AMENDMENT OF SOLICITATION/MODIFICATION OF CONTRACT				1. CONTRACT ID CODE		PAGE 1 OF 3 PAGES	
2. AMENDMENT/MODIFICATION NUMBER A00004		3. EFFECTIVE DATE 05/07/2026		4. REQUISITION/PURCHASE REQUISITION NUMBER		5. PROJECT NUMBER (If applicable) BI25NC201C06	
6. ISSUED BY Division of Eng. Services Seattle 701 Fifth Avenue, Suite 1600 Seattle WA 98104		CODE		7. ADMINISTERED BY (If other than Item 6) See block 6		CODE	
8. NAME AND ADDRESS OF CONTRACTOR (Number, street, county, State and ZIP Code)				(X)		9A. AMENDMENT OF SOLICITATION NUMBER	
				(X)		75H70126R00019	
				()		9B. DATED (SEE ITEM 11) 04/01/2026	
						10A. MODIFICATION OF CONTRACT/ORDER NUMBER	
CODE				FACILITY CODE		10B. DATED (SEE ITEM 13)

Solicitation: 75H70126R00019

Amendment 00004

SUPPLEMENTAL WIND CONE - TYPE L-806
NTS

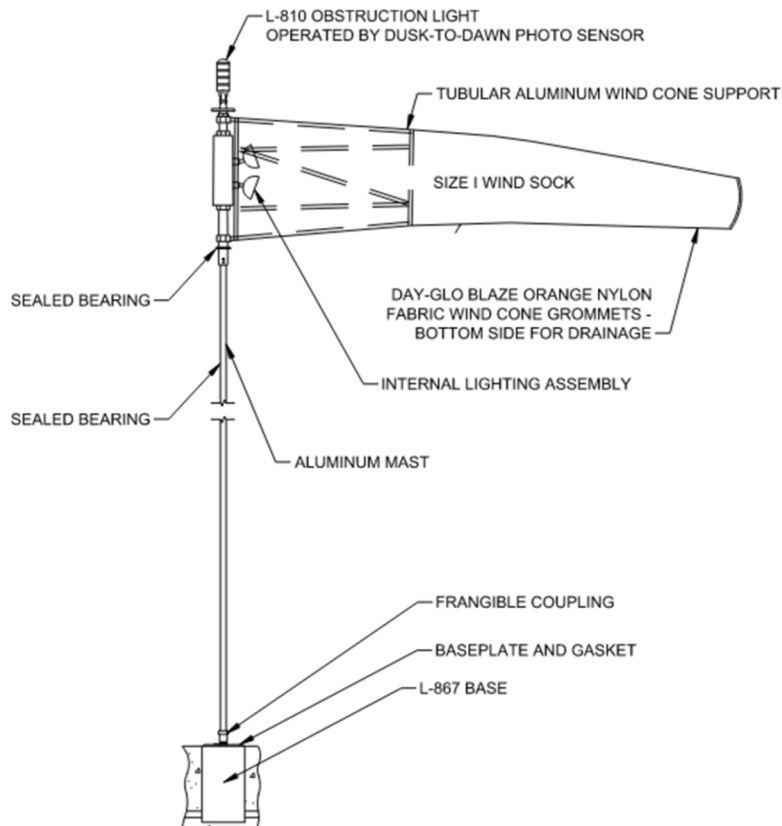
Q1. Note 5 on E101 indicates to go to sheet E702 to see the detail for the photo sensor. Sheet E702 has not been provided. Please provide E702 or clarify.

A1. Keynote 5 on E101 references the incorrect sheet. This detail was moved and the reference should be to sheet C401. The detail is titled "SUPPLEMENTAL WIND CONE – TYPE L-806." I have included a snip below. The detail is not specifically for the photo sensor control. It is intended to show the obstruction light on top of the wind cone.
